OGN-SMD and OGN product family combined.

Product Change Notification					PCN OGN family consolidation		
owner	creation date	release date	released by	change order no	rev	page	D10-063-657
sariogar	03.03.2022	14.04.2022	schulejo	2023609	A	1 of 4

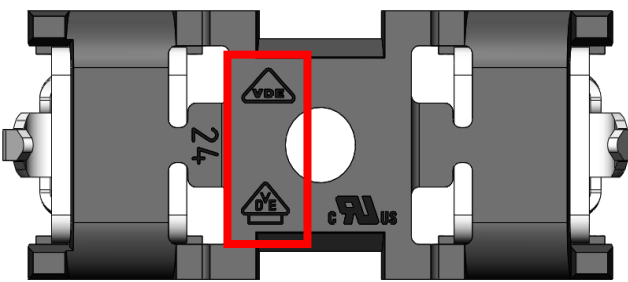
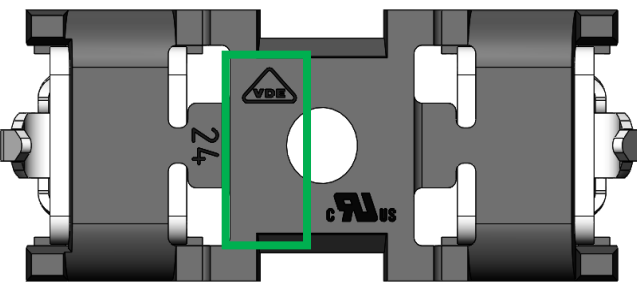
Current label for SMT	New label for SMT
Current label for THT	New label for THT
Current product rating	New product rating
UL 500V / 16A VDE 250 VAC / 4W / 10A VDE ÜG 500 VAC / 4W / 16A	UL 500V / 16A VDE 250 VAC / 4W / 10A VDE 500 VAC / 4W / 16A
Current configuration code	New configuration code
OGN-140-11-0 OGNSMD-250-11-0	OGN-140-11-0 (OGN for THT) OGN-250-11-0 (OGN for SMT) All standard OGN-SMD parts will have the configuration code changed by removing "SMD". The first number of the configuration code indicates the mounting method.

| ☒ Label | Verify your approval documents to use VDE ÜG file number 40045404 |
